MIL-R-63997B(AR)
AMENDMENT 4
31 July 1993

MILITARY SPECIFICATION

RIFLE, 5.56MM: M16A2

FIGURE 1. Targeting and accuracy diagram.

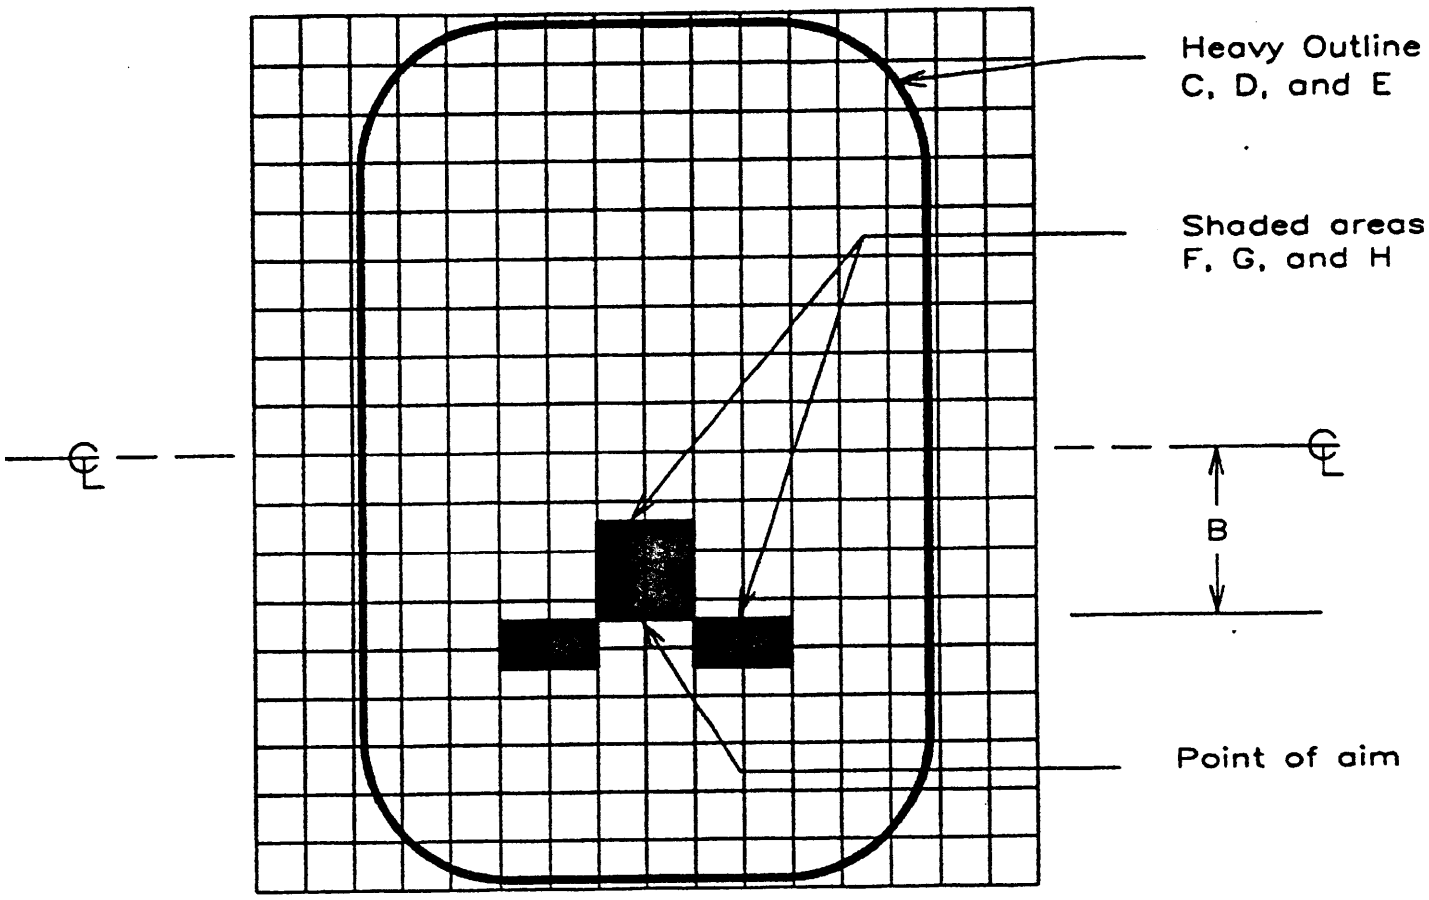
* 3.4.6: Delete in it's entirety and substitute the following:

"3.4.6 Targeting and accuracy. A series of 10 rounds fired from each rifle at a range of 91.4 meters shall be within the extreme spread and targeting area (heavy outline) specified in Figure I when the front and rear sights are set as follows. The normal rear sight peep (sight rotated fully rearward) shall be used with the rear sight set centrally in the slot for windage within plus or minus five (5) clicks. The top edge of the front sight post flange shall be set flush to .030 Inch below the bottom surface of the front sight slot. Ammunition shall be Government standard M855, 5.56mm ball cartridges conforming to Drawing 9342868 and shall have a vertical and horizontal standard deviation at 600 yards between 3.4 inches and 4.0 inches when measured in accordance with MIL-C-63989."
